Public Service  
Company of Colorado

October 16, 1985  
Fort St. Vrain  
Unit No. 1  
P-85367

SUBJECT: I&E Inspection Report 85-17

This letter is in response to the Notice of Violation (NOV) received as a result of an inspection conducted at Fort St. Vrain during the period of June 17, 1985, through August 16, 1985. The following response to the items contained in the Notice of Violation is hereby submitted:

FIGURE 1 CIRCULATOR TRIP LOGIC

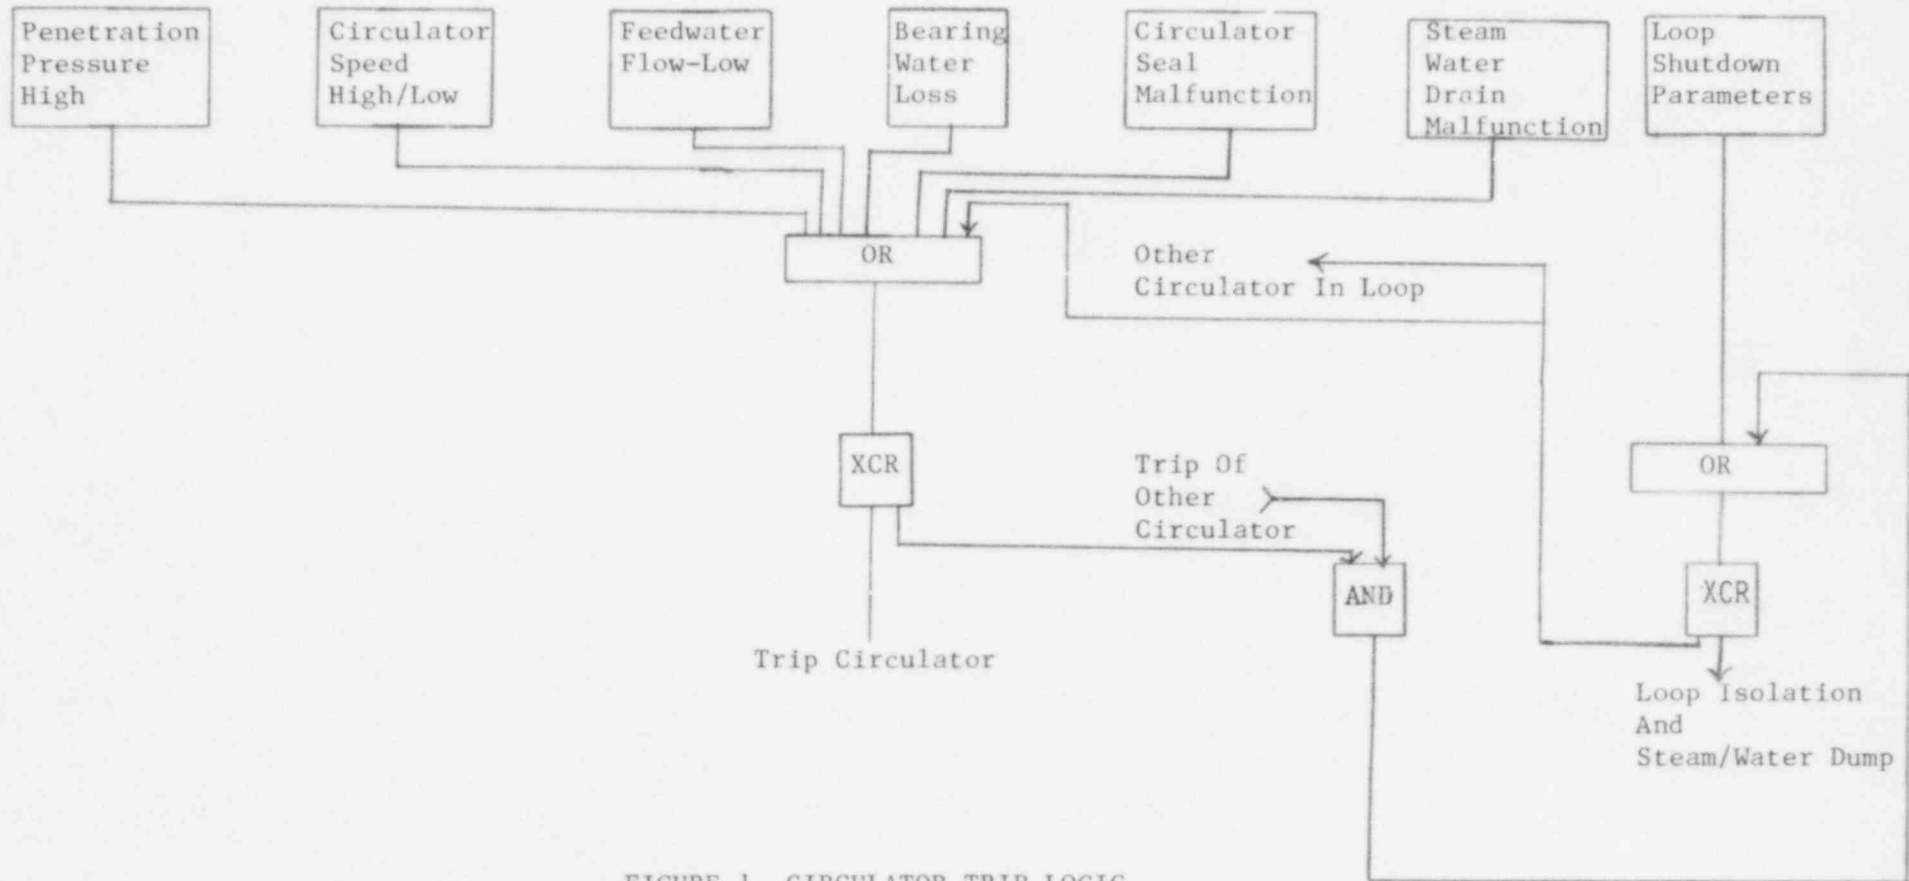
Contrary to the above, the licensee has considered circulator trips as not reportable. The licensee's daily logs list 9 circulator trips in 1984 and 7 circulator trips to date in 1985. Of these 17 circulator trips, only the trip of August 11, 1985, was reported to the NRC.

Although a single circulator trip does provide an input to the loop shutdown logic, and therefore the reactor scram logic (indirectly through the two loop trouble logic), a single circulator trip, by itself, does not actuate any RPS or ESF system. A similarity in the LWR case would be a condition which resulted in one input in a "one out of two taken twice" logic for initiation of an RPS or ESF system. In the LWR case, this is not reportable per 10CFR50.72 or 50.73 since the RPS or ESF has not yet been actuated.

Figure 1 shows a simplified schematic for the inputs that can cause a circulator trip. Those inputs listed under equipment malfunctions are the only ones which result in a single circulator trip. Note that each parameter is associated with an abnormal condition for a single circulator. The ESF (loop shutdown) actuation of a circulator trip always causes both circulators in the loop to trip. This latter is a reportable event.

PSC contends that, provided it is clear that an actuation is a result of an identified source other than RPS or ESF actuation, then the actuation is not reportable. The following discussion demonstrates that a single circulator trip by itself does not cause a RPS or ESF actuation, nor is it caused by a RPS or ESF actuation.

RPS or ESF actuation can cause a simultaneous trip of both circulators in a given loop as part of loop shutdown. However, there is no case where RPS or ESF actuation can cause the trip of a single circulator in a loop.

The above reasoning highlights the basis for determining that single circulator trip actuations are not reportable in accordance with 10CFR50.72(b)(2)(ii) or 50.73(a)(iv). However, trip actuations and deficiencies associated with helium circulator operation are routinely reviewed and evaluated for reportability in accordance with other 50.72 and 50.73 criteria for other safety considerations. Circulator trip actuations and abnormal operations are also routinely reviewed and investigated for plant availability concerns. Although the circulators were designed to operate independently of one another, and the Technical Specifications only require that one circulator in each loop be operable during power operation, a single inoperable circulator would significantly limit plant operation.
